COLLINS SUBDIVISION, 1ST ADDITION,
RESUBDIVISION OF LOTS 6 & 7

APPLICATION NUMBER 3 DATE July 6, 2017
 APPLICANT Collins Subdivision, 1st Addition, Resubdivision of Lots 6 & 7
 REQUEST Subdivision

DETAIL SITE PLAN

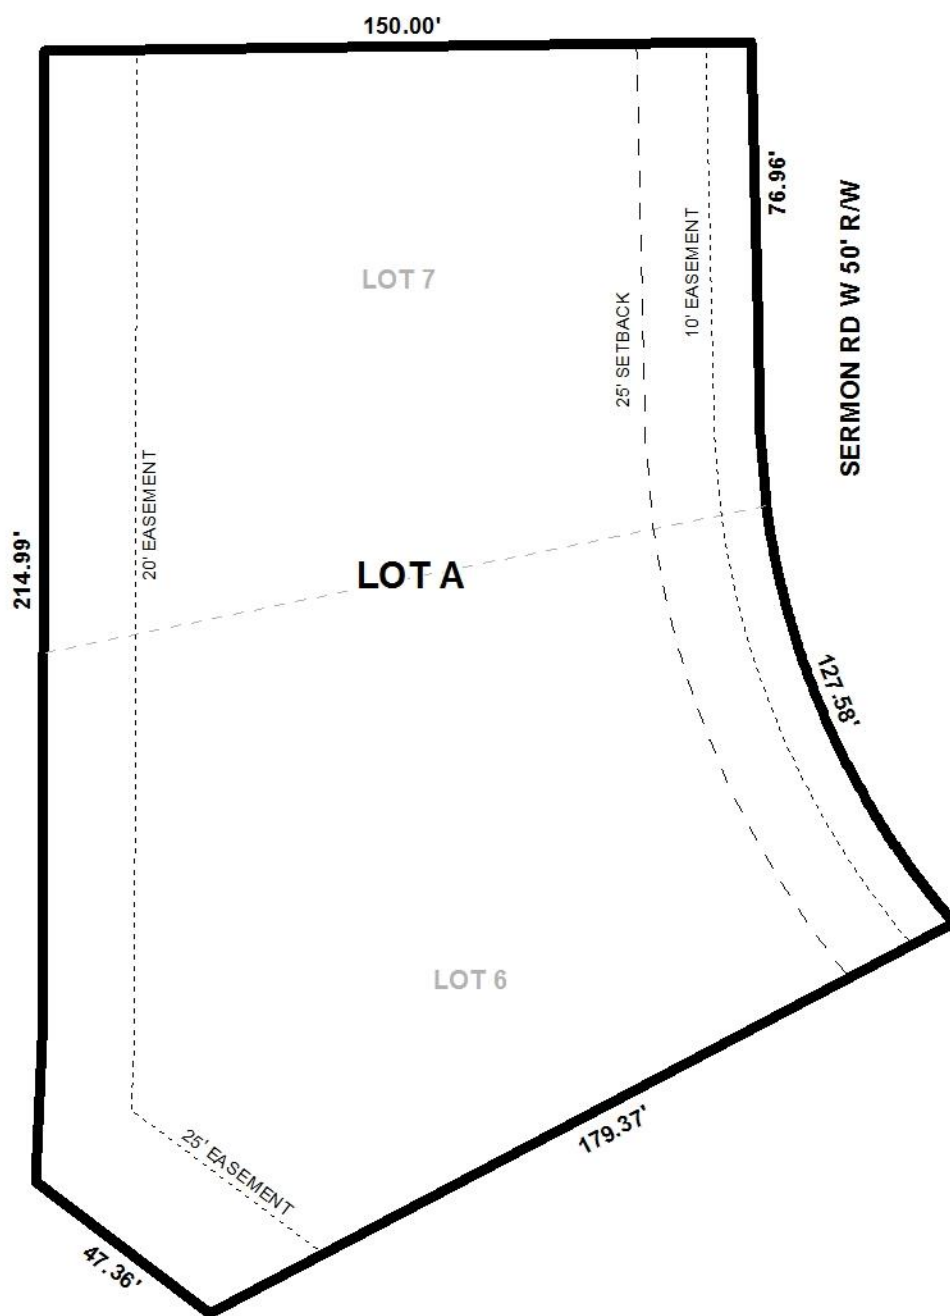
- A. Provide all of the required information on the SUBDIVISION PLAT (i.e. signature blocks, signatures, certification statements, written legal description, required notes, legend, scale, bearings and distances) that is required by the current Alabama State Board of Licensure for Professional Engineers and Land Surveyors.

- B. Add a Vicinity Map.
- C. Show and label the curve data.
- D. Revise the plat to label each lot with its size in acres and square feet, or the furnishing of a table on the Plat providing the same information.

- E. Provide a written legal description for the proposed subdivision and matching bearing and distance labels.
- F. Provide and label the monument set or found at each subdivision corner.

The subject lot has frontage on Sermon Road West. Sermon Road West is a minor street with curb and gutter, which requires a 50' wide right-of-way width. The preliminary plat illustrates the right-of-way width as 50' along Sermon Road West, and, if approved, should be retained on the Final Plat.

It should be noted that the preliminary plat still appears to illustrate the proposed lot as two separate lots. The Final Plat should be revised to clearly indicate the proposed lot as one lot.

The 25-foot minimum building setback line is depicted on the preliminary plat along Sermon Road West, and as such, should be retained on the Final Plat, if approved.

There is a 10' drainage and utility easement illustrated along the eastern perimeter of the proposed lot, as well as a 20' drainage and utility easement depicted along the Western perimeter of the proposed lot. Additionally, there is 25' drainage and utility easement depicted at the Southwestern corner of the proposed lot. If approved, a note should be provided on the Final Plat stating that no structures are to be erected within any easement.

The subdivision application indicates that the proposed lot will be serviced by public water and sanitary sewer systems; however, the preliminary plat does not indicate the lot size information in square feet and in acres to determine if the proposed lot exceeds the minimum lot size requirements for lots served by public water and sanitary sewer systems. The Final Plat, if approved, should be revised to indicate the lot size information in both square feet and in acres.

As a means of access management, a note should be placed on the Final Plat stating that the lot is limited to one curb cut to Sermon Road West, with any changes in the size, location and design to be approved by Traffic Engineering and conform to AASHTO standards.

- 1) Retention of the right-of-way width along Sermon Road West;
- 2) Revision of the Final Plat to clearly indicate the proposed lot as one lot;
- 3) Retention of the 25-foot minimum setback line along Sermon Road West;
- 4) Retention of all easements depicted on the preliminary plat, and placement of a note stating that no structures are to be erected within any easement;
- 5) Revision of the Final Plat to indicate the lot size information in both square feet and in acres;
- 6) Placement of a note on the Final Plat stating that the lot is limited to one curb cut to Sermon Road West, with any changes in the size, location and design to be approved by Traffic Engineering and conform to AASHTO standards;
